MEMORANDUM

Date: January 6, 2022

Re: Bishop Place Project - Modifications to Conditions of Approval
Petitions PLNHLC2019-01157 & 01158

12.73 Window reveals should be a characteristic of masonry and most public facades.

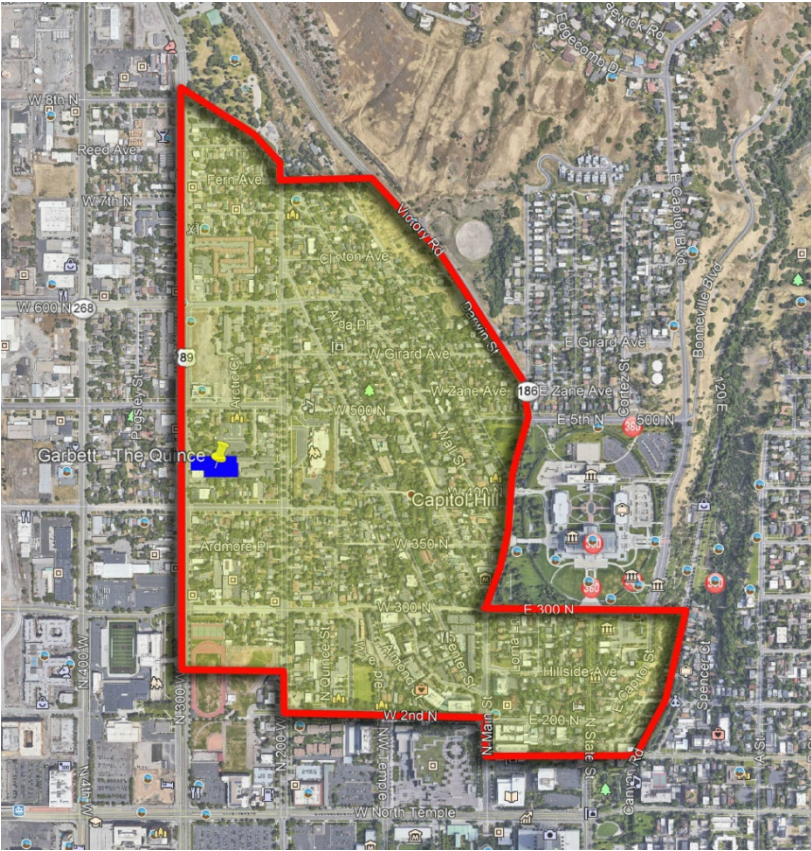
In addition, 12.73 provides specific guidance addressing window trim and reveal on new multifamily buildings, which conflicts with the applicant's proposal to use applied exterior trim to increase the reveal around the vinyl windows that were proposed:

MATERIAL/COLOR BOARD

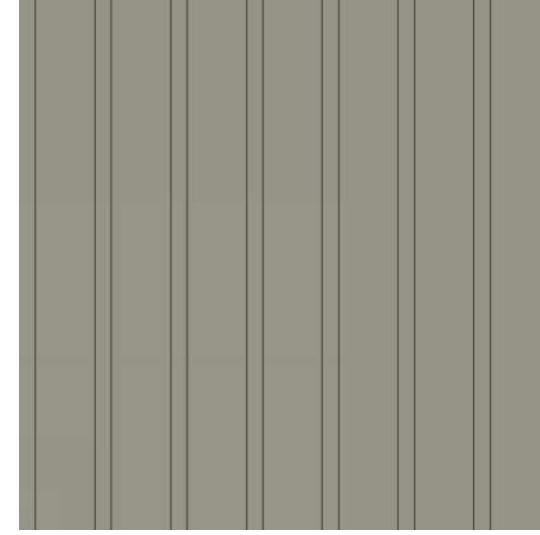
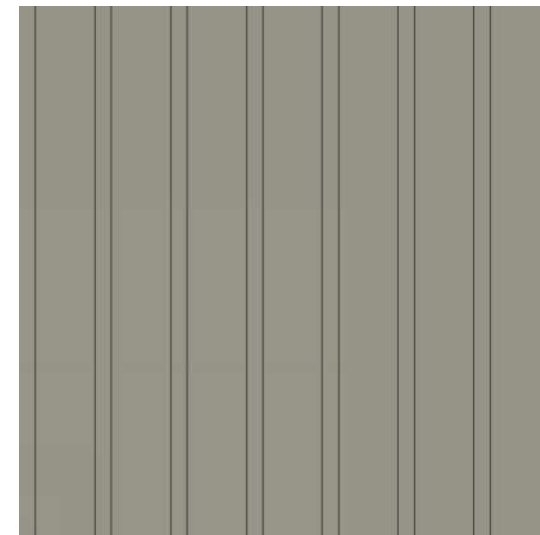
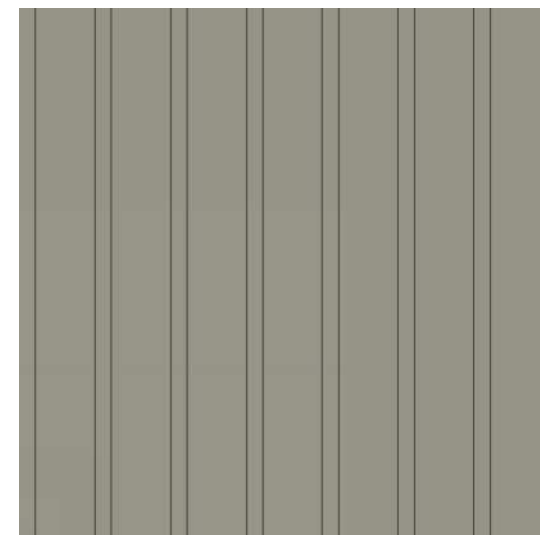
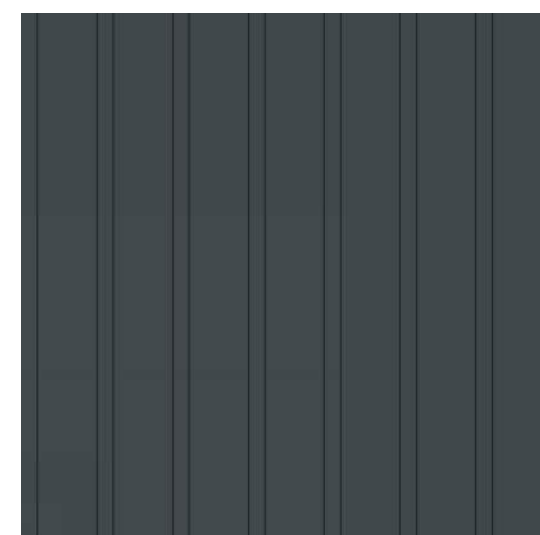
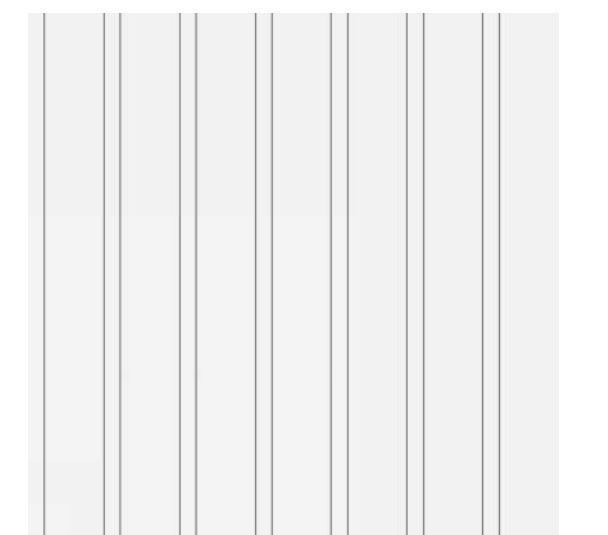
WINDOWS
Material: Vinyl
Manufacturer: TBD
Color: White

WINDOWS
Material: Vinyl
Manufacturer: TBD
Color: White

WINDOWS
Material: Vinyl
Manufacturer: TBD
Color: White

PROPOSED AMSCO ARTESIAN WINDOW

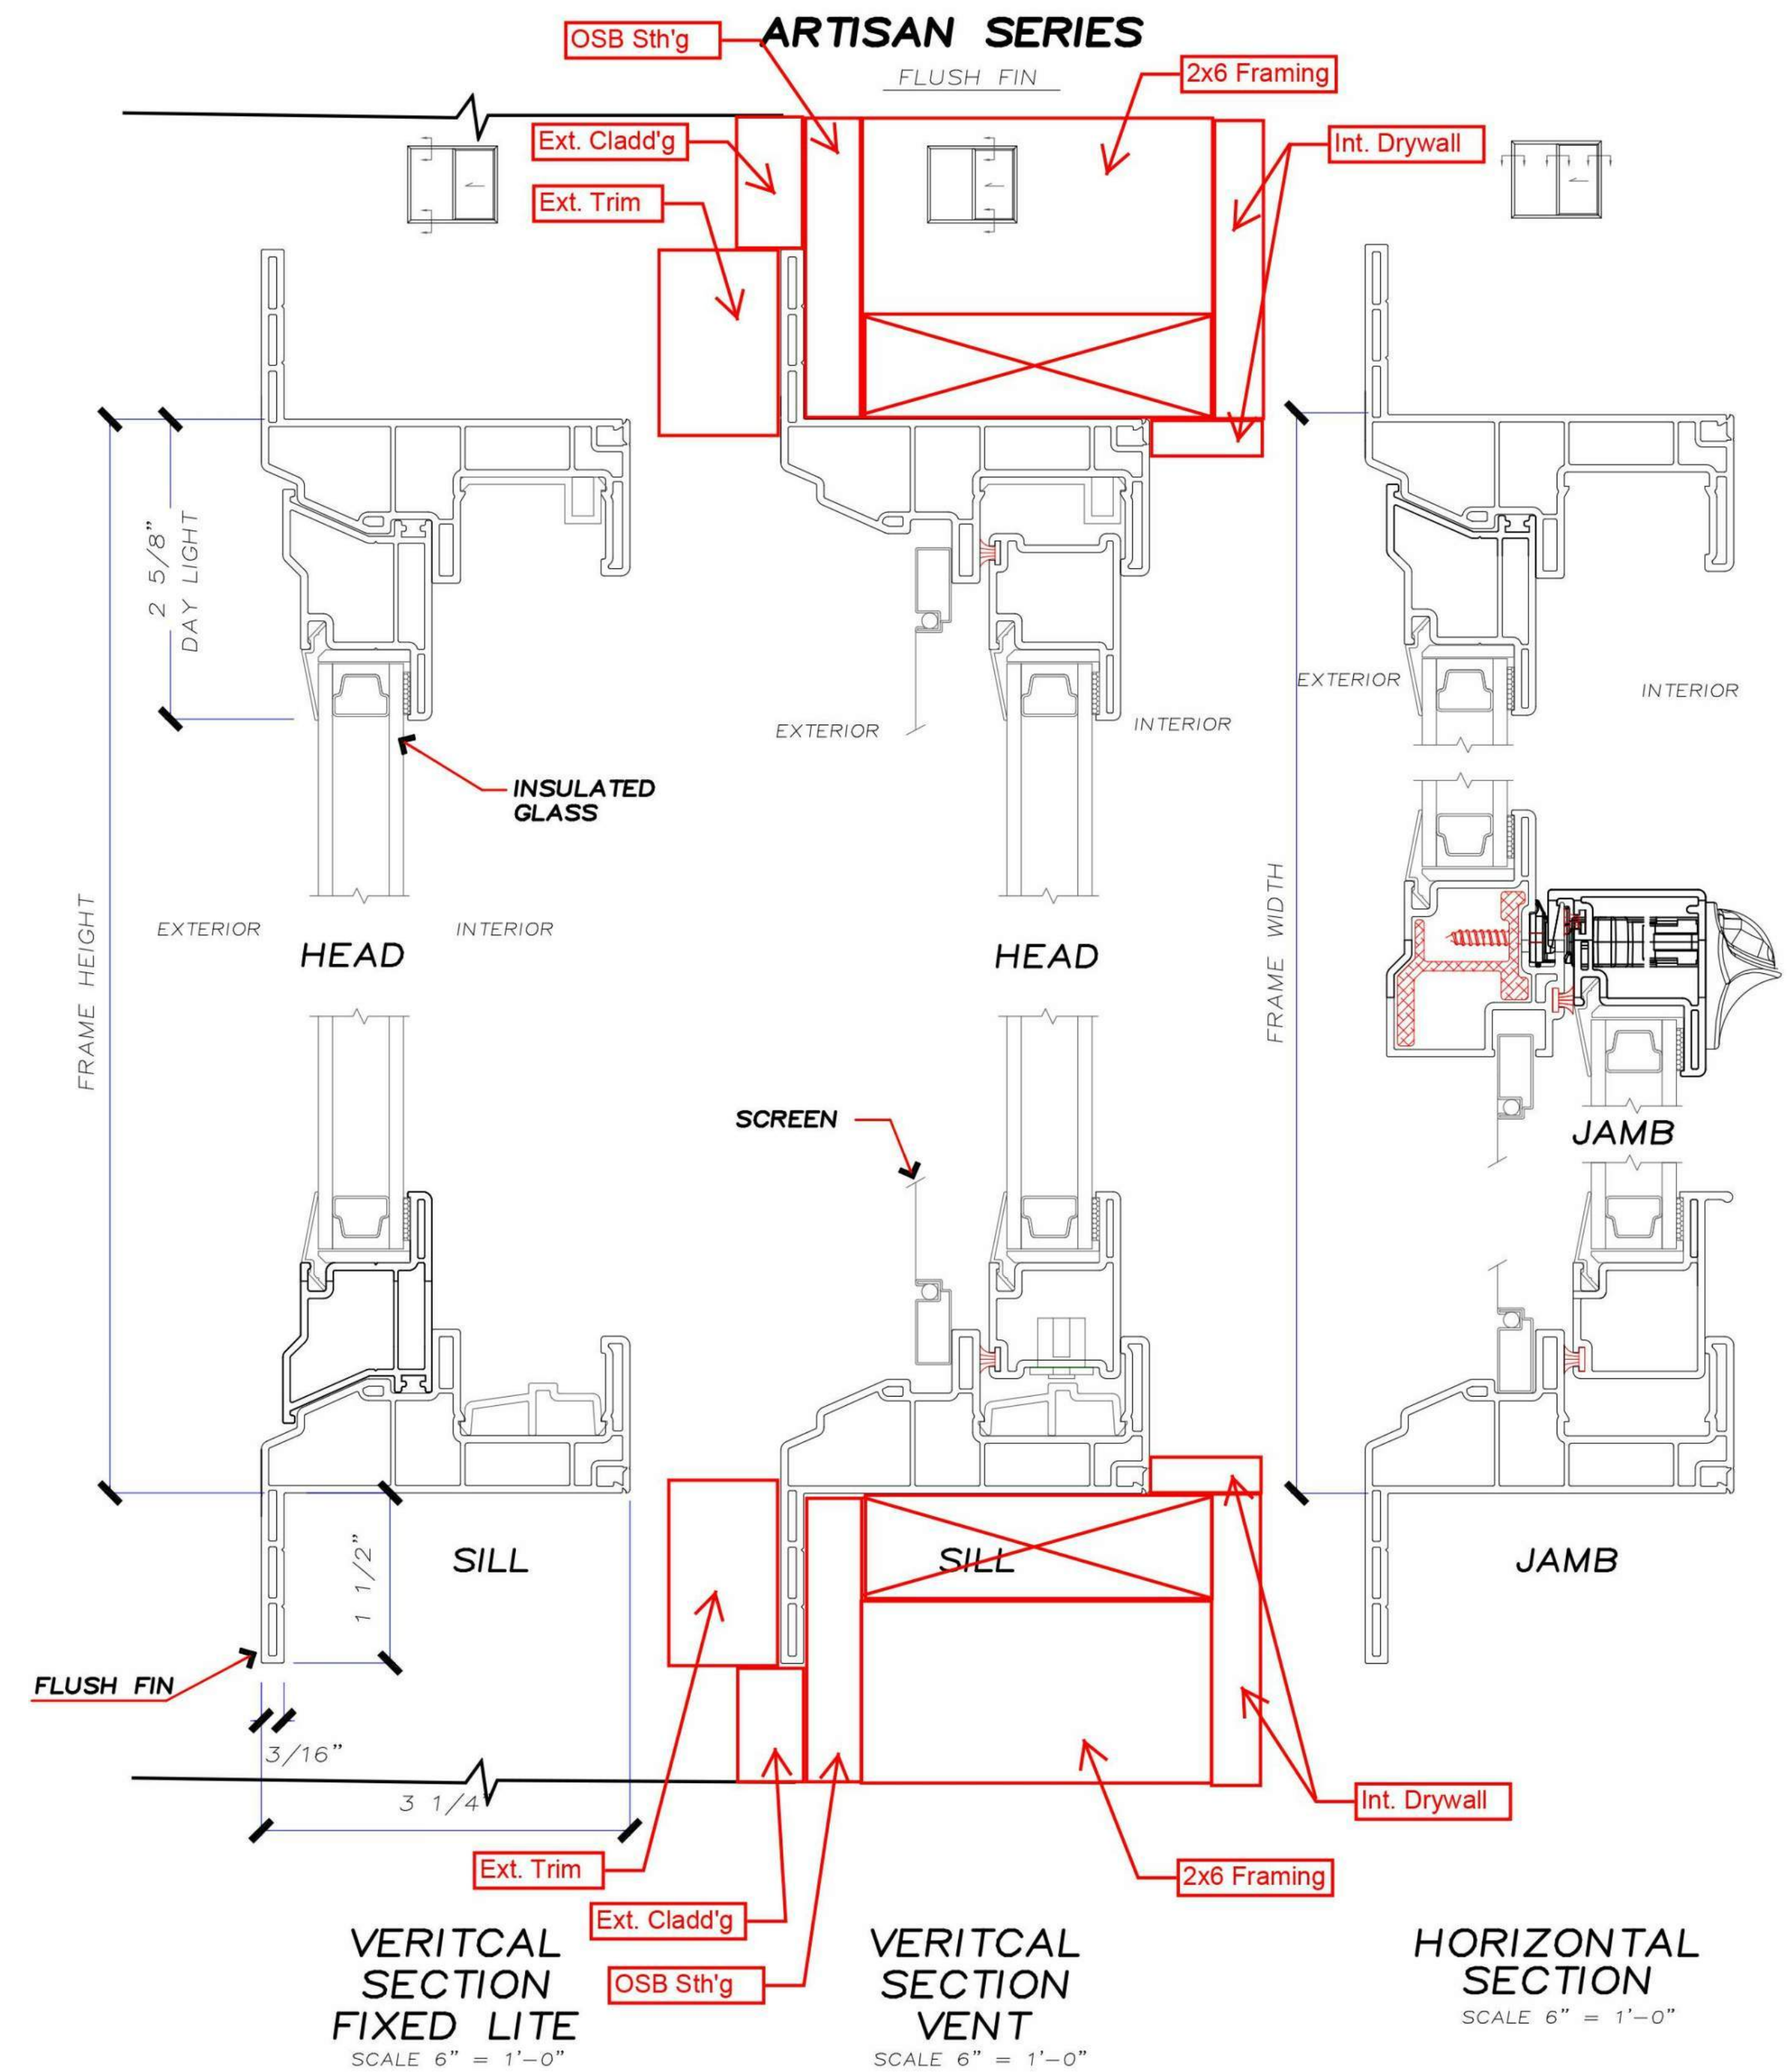
The applicant is requesting to remove both Condition #1 and Condition #2 from the approval and use the Amsco “Artesian” Series vinyl windows on the project, as originally proposed. Vertical sliding, horizontal sliding, and casement configurations would not vary from the design approved by the HLC, nor would the size or placement of the windows. In exchange for the modification to the conditions, the applicant would construct all-electric, solar-powered units in the development.

WITH THIS WINDOW THE NAILING FLANGE IS BROUGHT TO THE FRONT FACE OF THE WINDOW FRAME, THIS HAS THE EFFECT OF PUSHING THE WINDOW FURTHER BACK FROM THE FINISHED FACE OF THE BUILDING, CREATING MORE OF A RECESSED LOOK. THIS IS FURTHER ACCENTUATED BY ADDING TRIM AROUND THE WINDOWS TO PROVIDE ADDITIONAL DEPTH.

WITH THIS WINDOW THE NAILING FLANGE IS SET BACK 1"+ FROM THE FACE OF THE WINDOW FRAME, THIS HAS THE EFFECT OF BRINGING THE WINDOW FRAME AND GLASS MORE IN LINE WITH THE FINISH FACE OF THE BUILDING MATERIALS, MAKING THE WALL LOOK FLAT.

Staff further recommends that the Commission leave Condition 1 as approved, in order for Planning Staff to work with the applicant to identify a type of window that meets New Construction Standard 21.34.020(H)(6)(c) – Windows, and associated design guidelines. The final window may include a durable frame material such as fiberglass or composite wood. As with the previous approval, the final window design shall be inset approximately three to four inches from the wall plane to the window glass.
